Office Action Summary	Application No. 10/530,570	Applicant(s) FOERSTERLING ET AL.	
	Examiner Melody M. Burch	Art Unit 3683

DETAILED ACTION

【図 1】

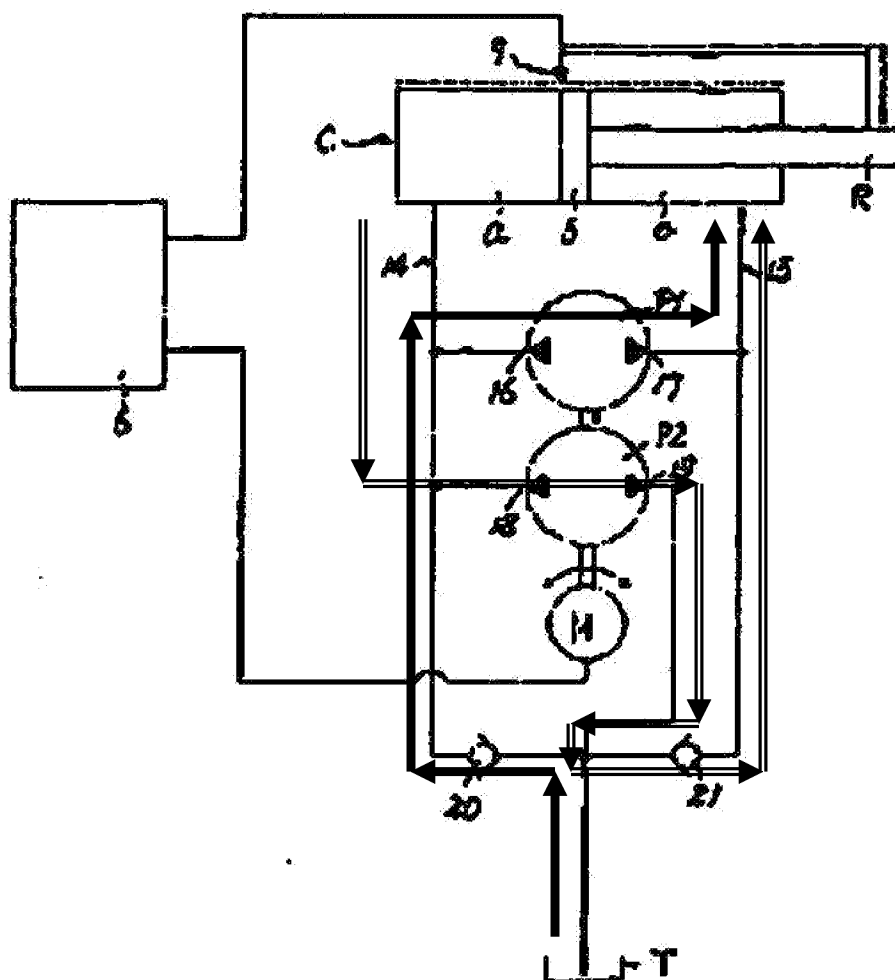
With regards to the 103 rejections, Applicant amended claim 14 to read that the "second hydraulic unit is arranged in a pressure medium flow path between the ring chamber and the cylinder chamber and the first hydraulic unit is arranged in a pressure medium flow path between the tank and the ring chamber whereby the pressure medium flow path is bypassing the second hydraulic unit." The claimed pressure medium flow paths have been illustrated in the annotated version of figure 1 of JP'403 on the following page for Applicant's convenience:

Examiner notes that the double line arrows represent a pressure medium flow path in which the second hydraulic unit P2 is arranged which extends between the ring chamber and the cylinder chamber in which is arranged as illustrated. The solid line arrows represent a pressure medium flow path in which the first hydraulic unit P1 is arranged which extends between the tank T and the ring chamber as illustrated. The annotated version of figure 1 clearly illustrates that the pressure medium flow path in which the first hydraulic unit is arranged bypasses the second hydraulic unit. Accordingly, the rejections have been maintained.
